Docket Item # 11
BAR CASE# 2009-0035

BAR Meeting
April 1, 2009

ISSUE: Alterations
APPLICANT: Kenneth Carpi
LOCATION: 202 Duke Street
ZONE: RM/Residential

The Applicant is requesting approval of a Certificate of Appropriateness for the installation of two, HVAC condensers on the rooftop of the rear portion of the house at 202 Duke Street.

Figure 9: Location of Condenser Units

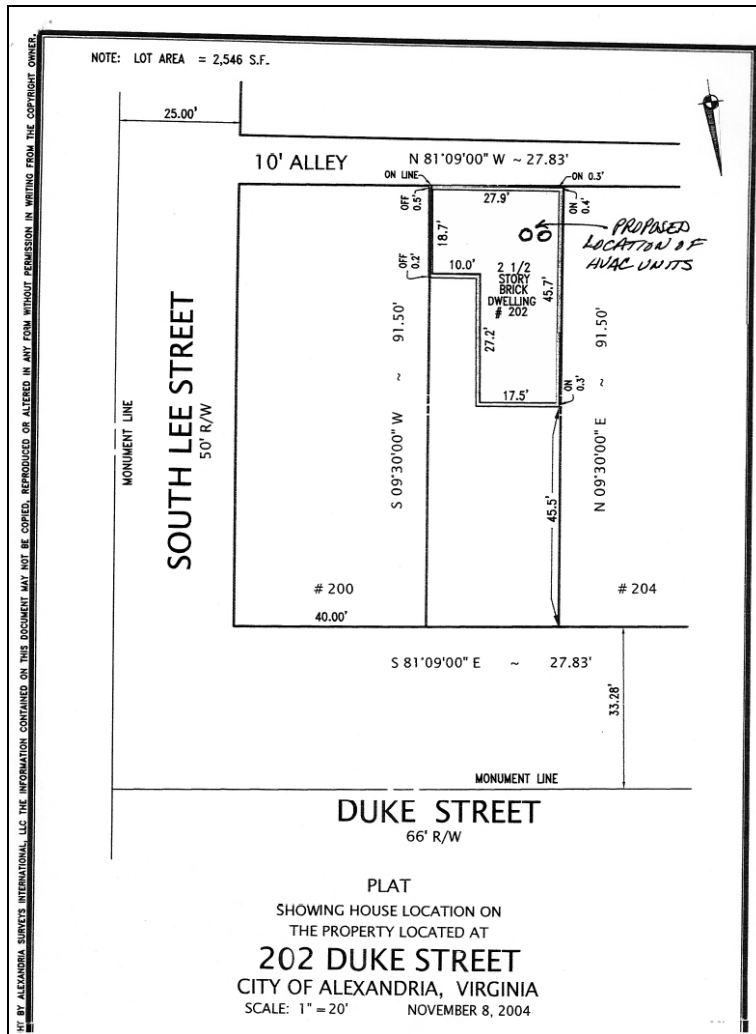
The current application has not provided the Board with documentation of the current structural analysis of the historic roof upon which the condensers are proposed to be mounted. Condensers of this size individually weigh approximately 225 pounds or more. An increase of 450 pounds of weight on top of this historic roof structure may compromise the "flounder's" structural integrity especially if snow loads are added into the formulary. As such, this roof's structural system needs to be analyzed to determine if it can support the additional weight of these units, without requiring an alteration to its structural system.

From a compatibility standpoint, the proposed location of the condensers is problematic for two main reasons. The current location visually obstructs the pure form of the "flounder", which is a very unique roof form identified as a character-defining feature within the Old and Historic District. Secondly, the installation of the condensers will require penetration into the roof's sheathing. It is standard preservation practice not to support the installation of modern

If the Applicants are unable to find alternative solutions, the Board should be provided with a detailed written justification as to why the units cannot be installed in the existing yard or mounted on another non-historic massing, and an analysis of the existing flounder’s roof structural system with proposed condenser installation. This analysis should include potential snow loads.

It is recommended that the Board defer this proposal for re-study. The study should include an evaluation of the property for alternative sites for proposed condenser units. Some possible locations to consider include on the existing second floor roof deck, behind the approved 2007 shed with landscape screening, or altering the existing roof slope of the approved 2007 shed to enable the condenser units to be mounted upon it. This would also require designing a architecturally compatible screen to surround the units, as they would be housed in view of the front of this resource.
